Technical Service Information

FORD E40D NEW DESIGN INTERMEDIATE SERVO PISTON ASSEMBLY

Figure 1

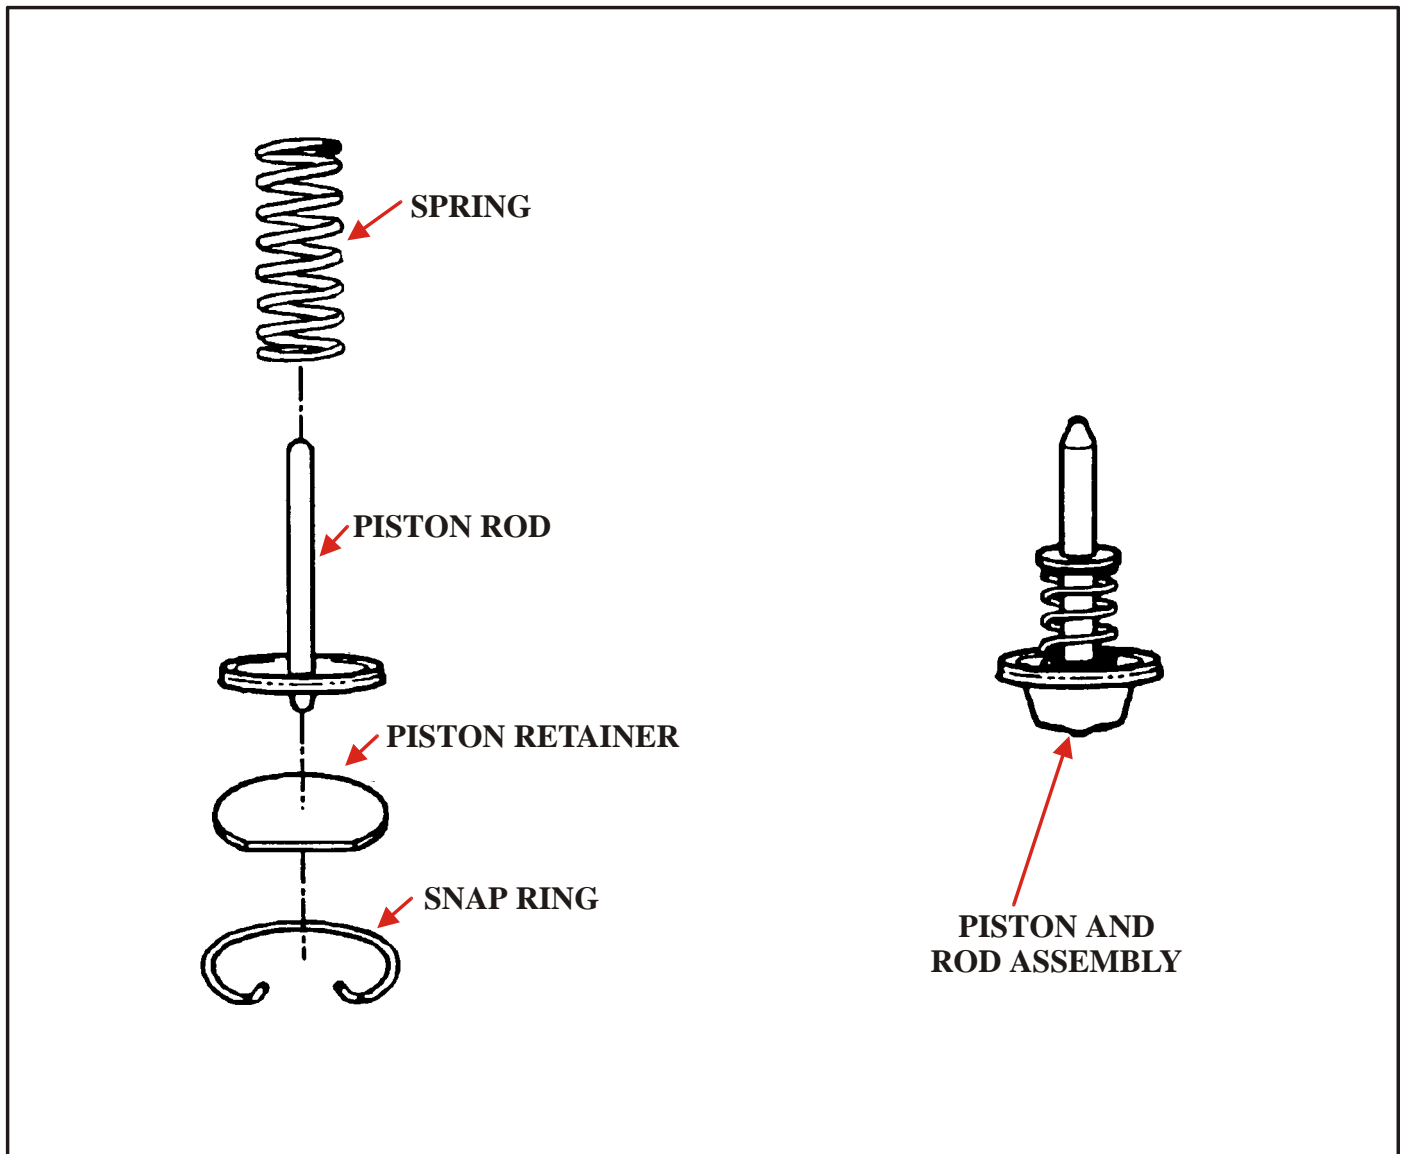
CHANGE: Beginning on August 8, 1995, all 1996 model E40D transmissions were produced with a new design Intermediate Band Apply Servo Assembly (See Figure 1).

- (1) **INTERMEDIATE SERVO PISTON** - Total change in design, as shown in Figure 1.
- (2) **SERVO PISTON RETAINER** - Eliminated, as shown in Figure 1.
- (3) **RETAINING SNAP RING** - Eliminated, as shown in Figure 1.
- (4) **TRANSMISSION CASE** - Snap ring groove in the case piston bore was eliminated, as it was no longer need (See Figure 2).

- (1) When replacing the Intermediate Band Apply Servo Assembly becomes necessary, either design level (Previous or New) can be used in a previous model transmission case, as the new design level part will retro-fit back to all previous model units.
- (2) When using the new design piston and seal assembly in a previous model transmission, discard the piston retainer and the snap ring.
- (3) If you have the later model transmission without the snap ring groove in the piston bore, on& the new design piston and seal assembly can be used.

Figure 2

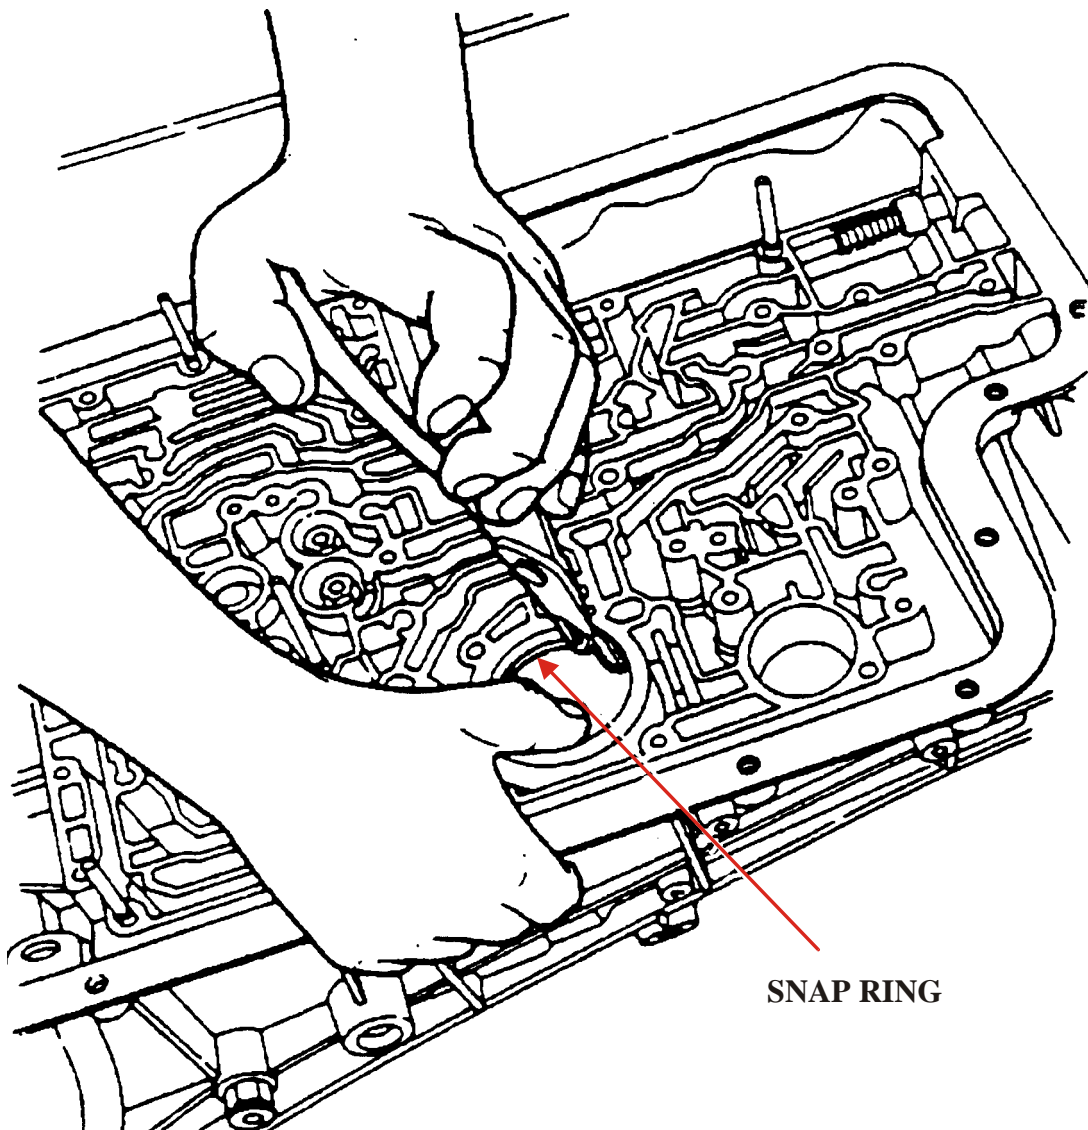
**SNAP RING GROOVE IN CASE BORE
ELIMINATED ON LATER MODELS**
